## Staff Report & Recommendations

### Sunrise Terrace Subdivision: Type III

### Preliminary Plat and SEPA DNS

(2014-006-SUB) October 5, 2015

Figure 3 - Sunrise Terrace Phasing Plan

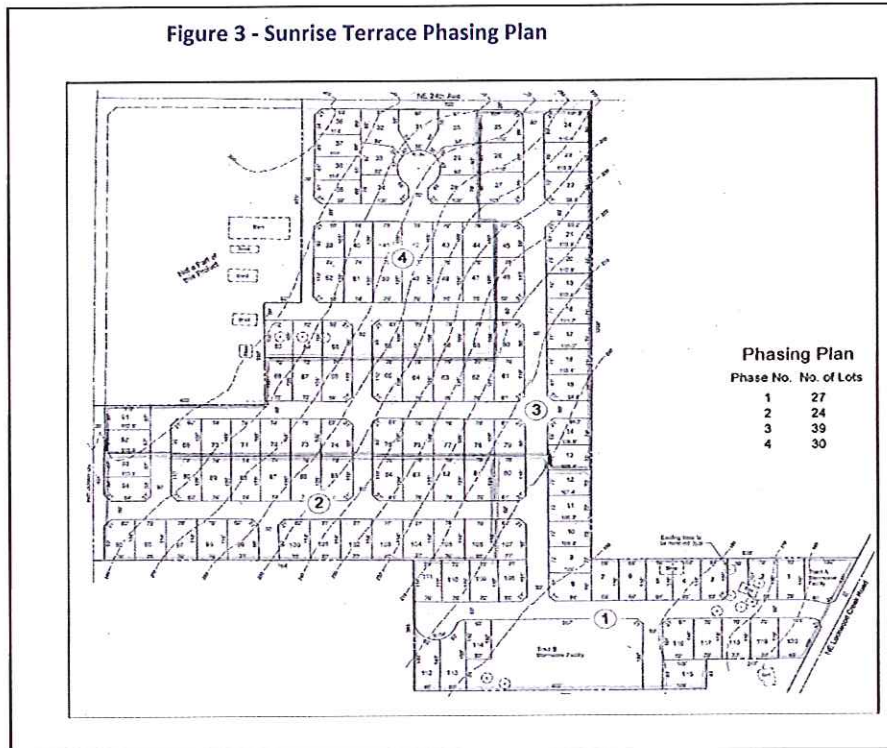
Sunrise Terrace is divided into four phase. (See Figure 3 of this report.) Phase 1 will accommodate the stormwater facilities (Tract A and Tract B) for the entire development. Parks are not required and the Applicant has elected to not provide parks or trails in any phase.
